PanGEO
INCORPORATED
Geotechnical & Earthquake
Engineering Consultants

April 4, 2019
Revised April 24, 2019
File No. 14-128.200

Subject: **Response to Geotechnical Review Comments (Revised)**
Proposed Single-Family Residence
4634 E Mercer Way, Mercer Island, WA

Static Slope Stability Analysis
Post-Construction Condition

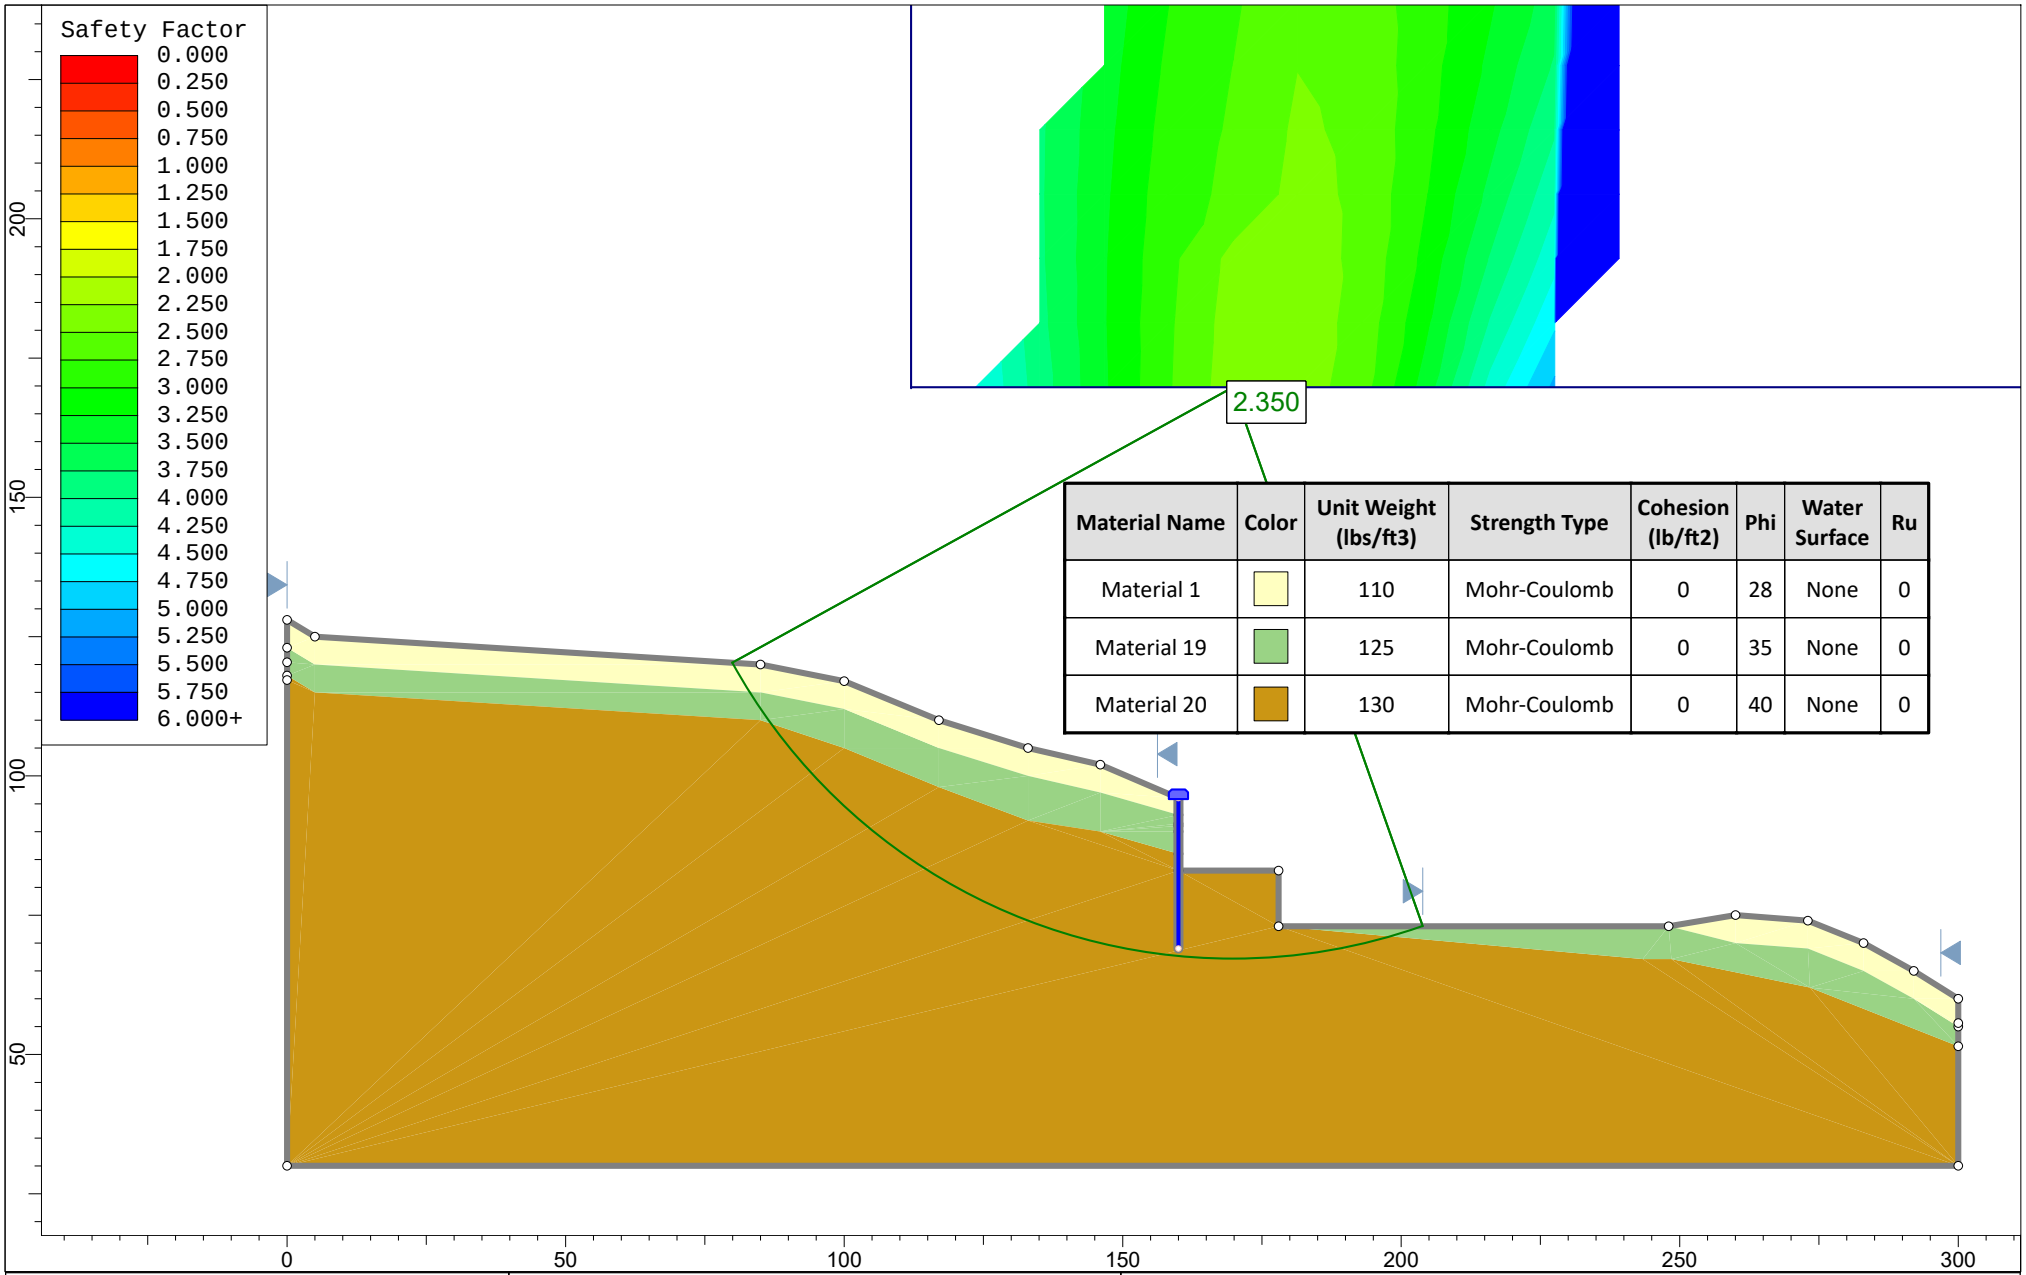
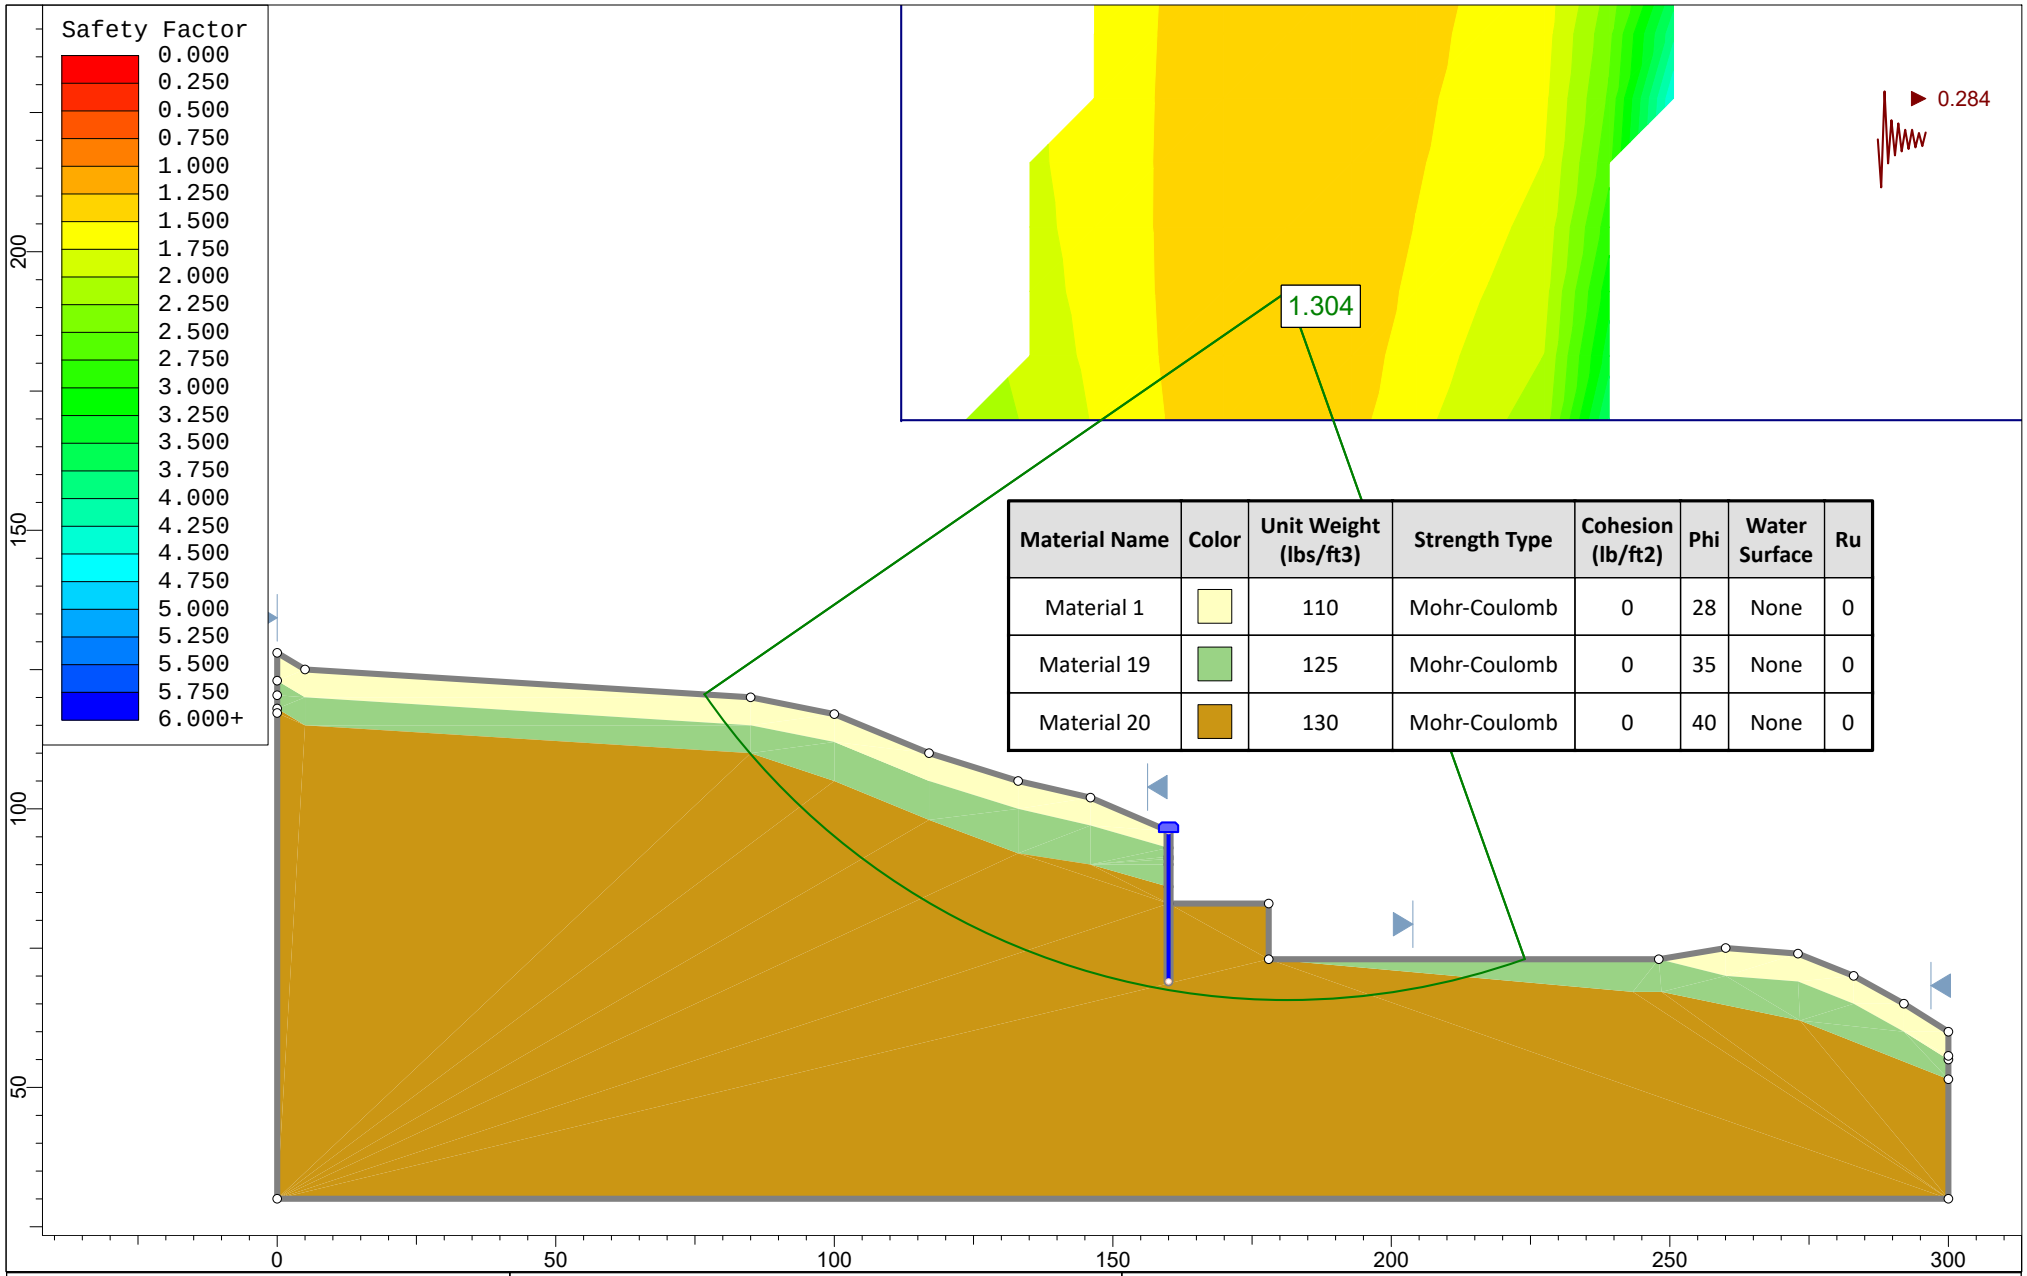
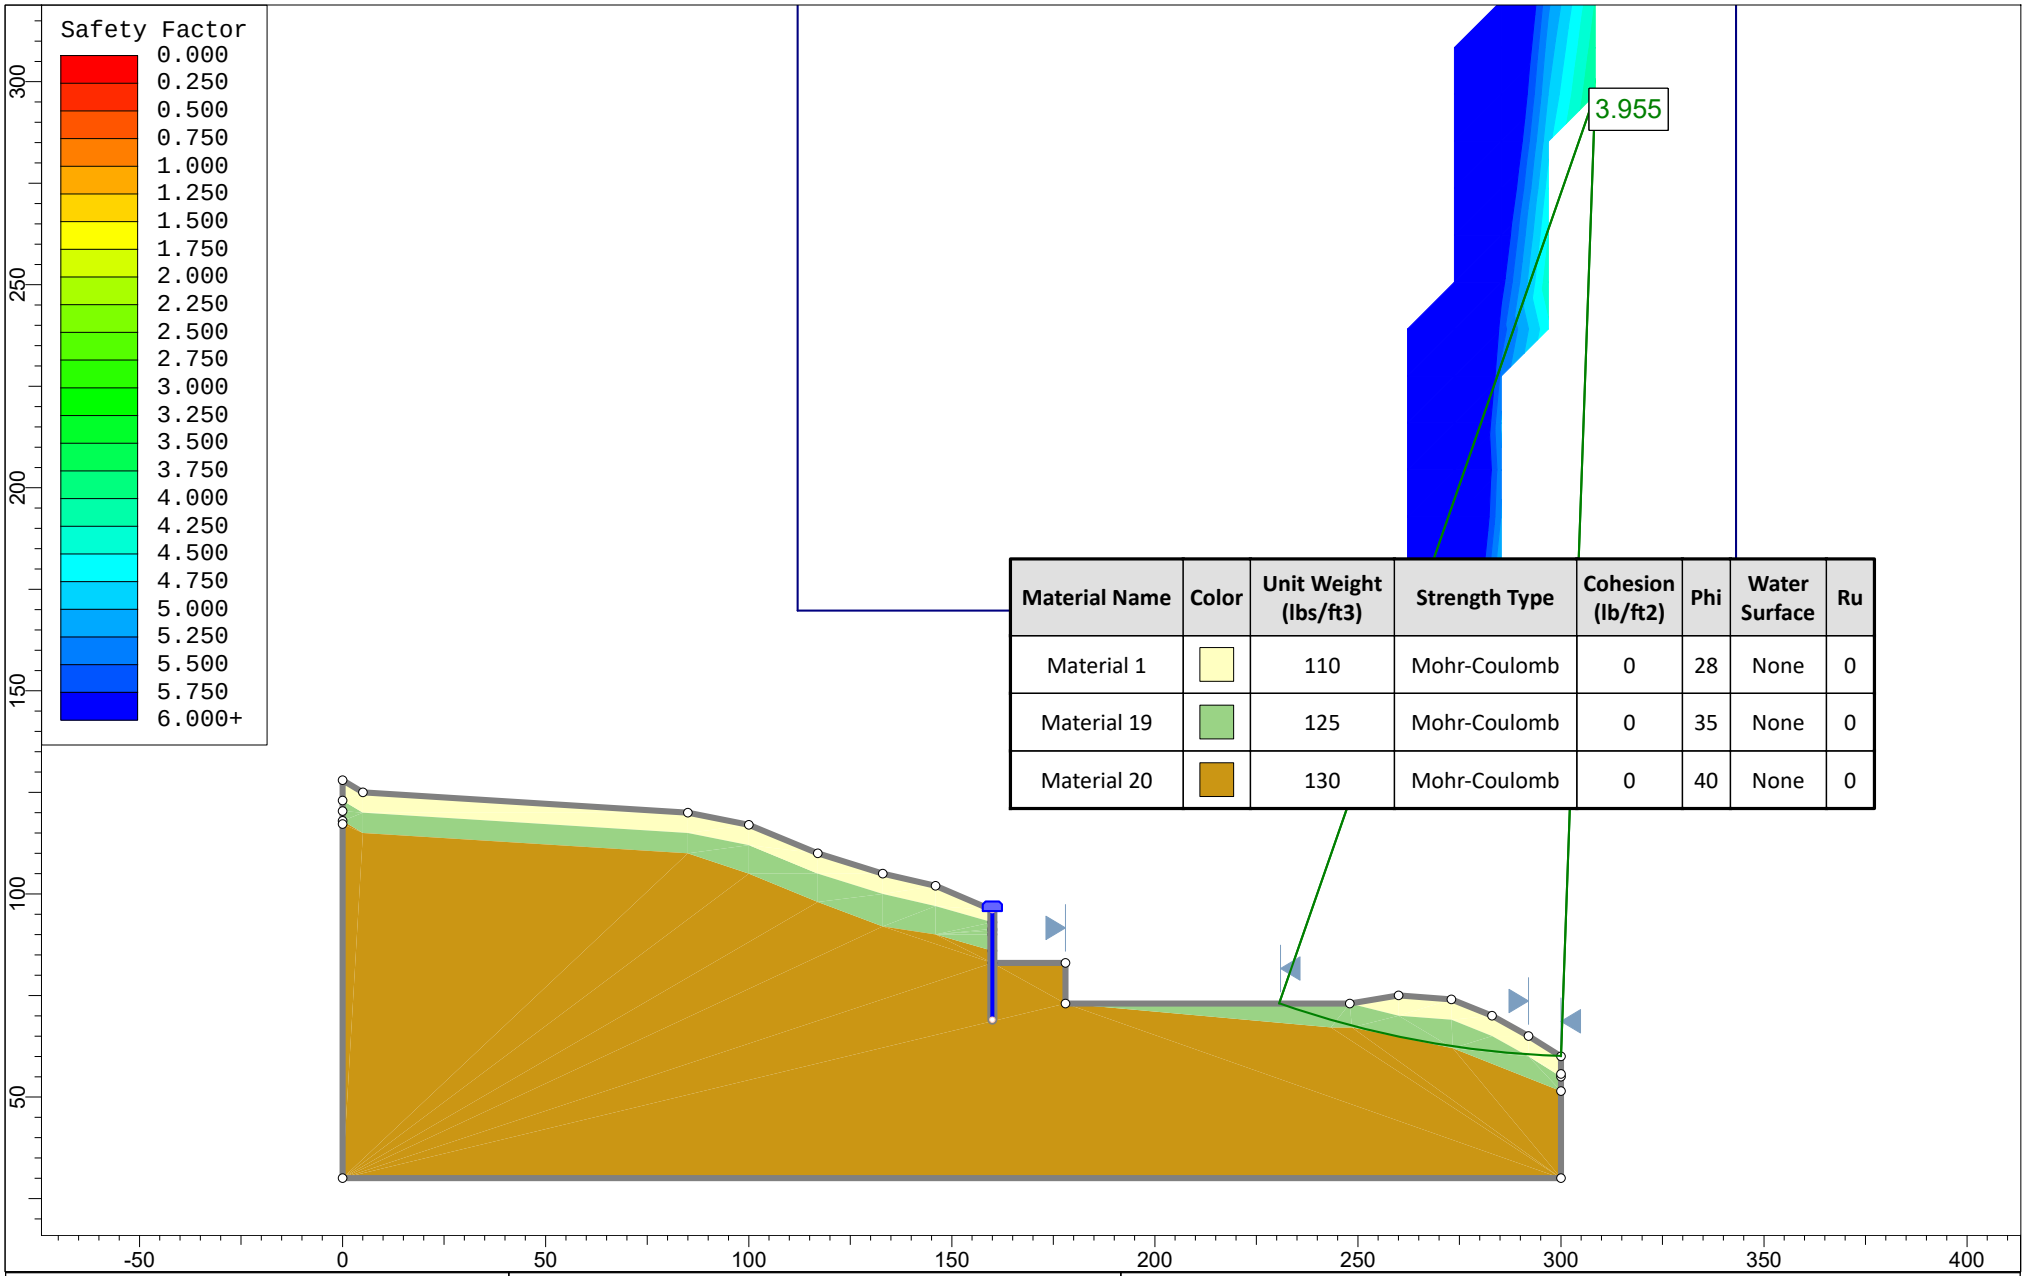
2. Overall Slope Stability analysis (Comment #2)

Our slope stability analyses were performed using the computer program *Slide v6.008* (Rocscience, 2010). The seismic stability was analyzed using pseudo-static procedures, where the effect of earthquake ground shaking is represented by the use of a "seismic coefficient" in the stability calculations. In our pseudo-static stability analysis, one-half of the expected peak ground acceleration, or 0.284g, was used. The results of our analyses are shown in Figures 4 through 8.

In summary, based on the results of our additional analysis and evaluation, it is our opinion that the site has the adequate factor of safety against potential failures under the

static and seismic conditions, and will not likely have catastrophic slope failure that may threaten life safety of the occupants.
